- 8. Bear Cove Airpark Addition; KPB File 2024-014
McLane Consulting Group / Kersten
Location: Pomeroy Road
Remote Area**

**ITEM #8 - PRELIMINARY PLAT
BEAR COVE AIRPARK ADDITION**

KPB File No.	2024-014
Plat Committee Meeting:	February 26, 2024
Applicant / Owner:	Jack C Farnworth Residuary Trust of Soldotna
Surveyor:	James Hall / McLane Consulting Inc
General Location:	Bear Cove Kachemak Bay

STAFF REPORT

BEAR COVE AIRPARK ADDITION

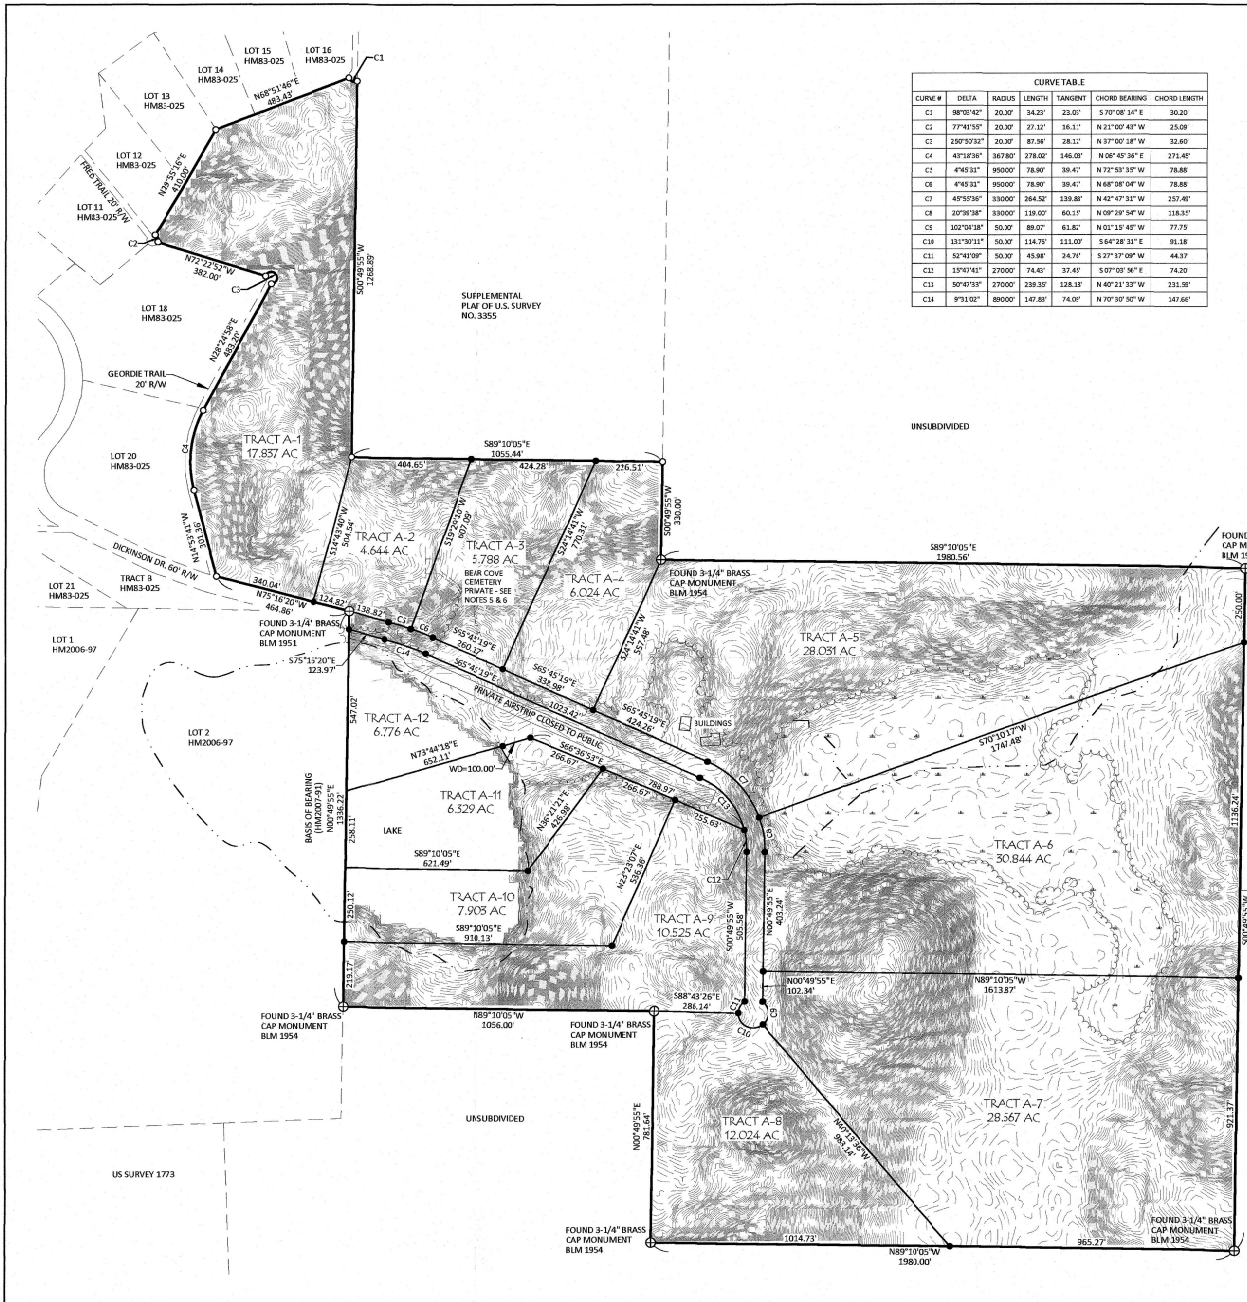
The road appears to have some steep segments along the route. **Staff recommends:** the surveyor submit centerline profiles and cross sections for RSA review as additional right-of-way or easements may be required for side slopes.

The plat contains many steep areas as shown by the contours and shading on the drawing. The contours should be removed for the final submittal and the shading lightened.

The land was first surveyed as US Survey 3018 and 3355 by the US Department of Interior in July of 1954. In 1955 US Survey 3355 has a supplemental plat drawing and filed with it dividing Lot 1 Dickson Subdivision HM 83-25 subdivision US Survey 3018 into 24 lots and a 60’ road dedication leading to this subject property. Since the platting Dickenson Dr has been renamed to Pomeroy Rd and should be changed on the drawing.

HEA has requested the front 10 feet of the 20 building setback be labeled as a utility easement with a plat note.

- KPB file no is 2024-014
- Dickenson Dr has been renamed to Pomeroy Rd, please correct.
- Identify the few roads that are in the area on the vicinity map.
- Parcels to the east and south should be labeled “unsubdivided”
- Create a typical detail for the 10’ utility easement and 20’ building setback to be shown instead of on drawing.

Label the line of the lake in the plat and on adjacent property or add the line type to the legend

- The front 10 feet of the building setback and the entire setback within 5 feet of the side lot lines, is a utility easement granted with this platting action.
- Roads must meet the design and construction standards established by the borough in order to be considered for certification and inclusion in the road maintenance program (KPB 14.06).
- The borough will not enforce private covenants, easements, or deed restrictions per KPB 20.60.170.
